RE: 2200 Vista Oriente
Revised Grading and Drainage Plan
Engineer's Stamp Date: 09/14/23
Hydrology File: H10D033

RE: 2200 Vista Oriente
Revised Grading and Drainage Plan
Engineer's Stamp Date: 08/06/23
Hydrology File: H10D033

Based upon the information provided in your submittal received 09/05/2023, the Revised Grading & Drainage Plans **is not** approved for Building Permit and Grading Permit. The following comments need to be addressed for approval of the above referenced project:

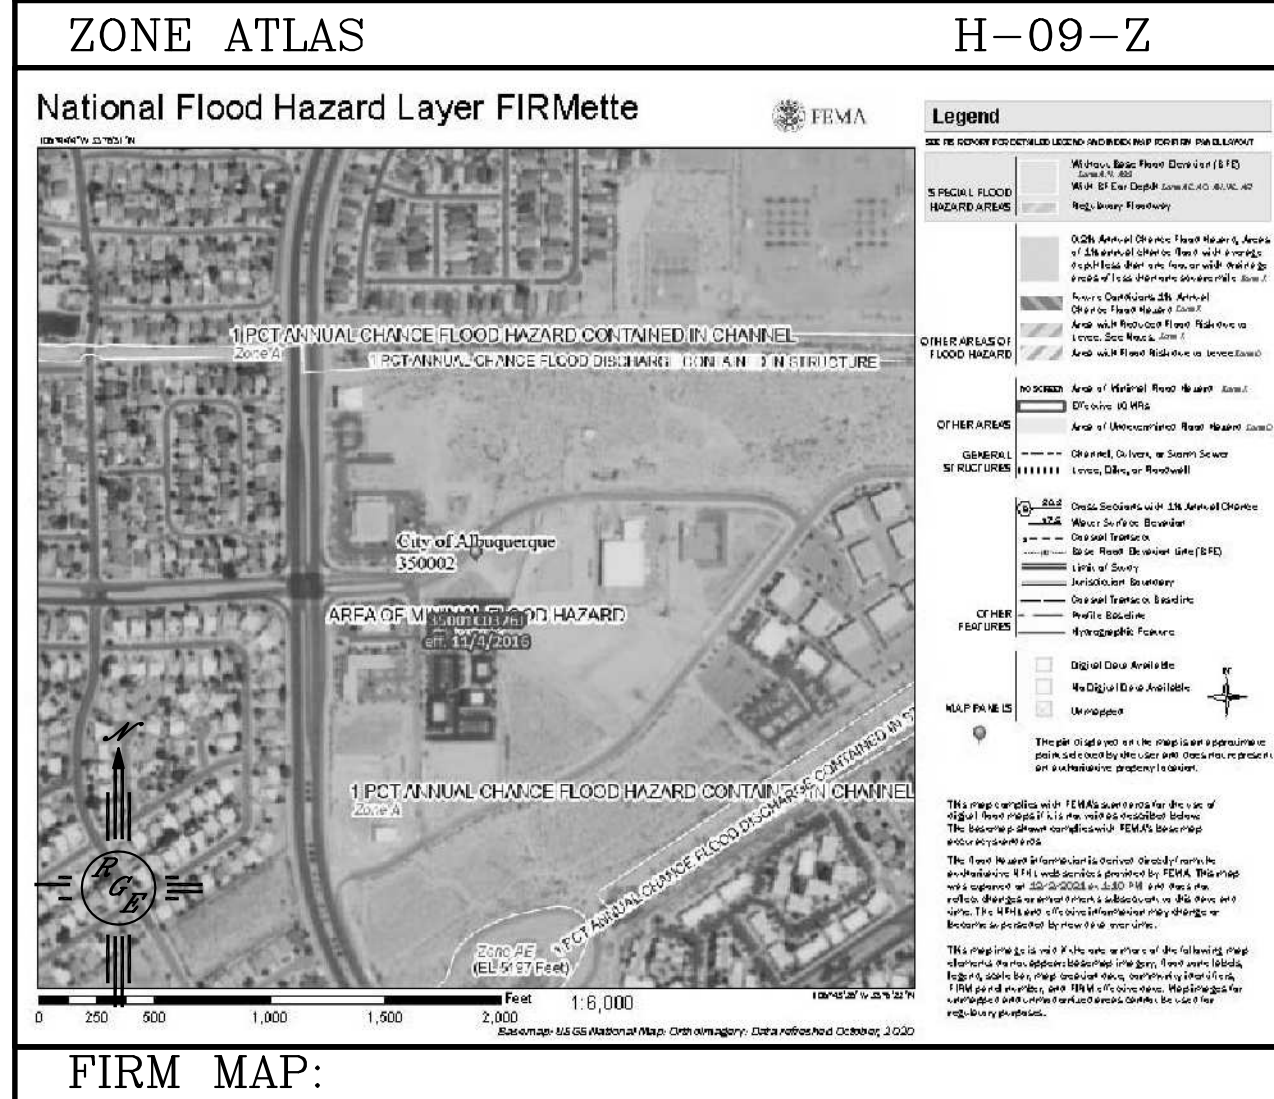
1. Please show the shared dumpster location for both of these restaurants. Also, for trash enclosures serving food service developments, trash enclosures must demonstrate control of liquids from dumpster areas per DPM by containing runoff from the dumpster area, preventing outside drainage from entering the dumpster area, and discharging to the sanitary sewer. Please show an inlet in the middle and label. "Inlet to be connected to the sanitary sewer. See Utility Plan."
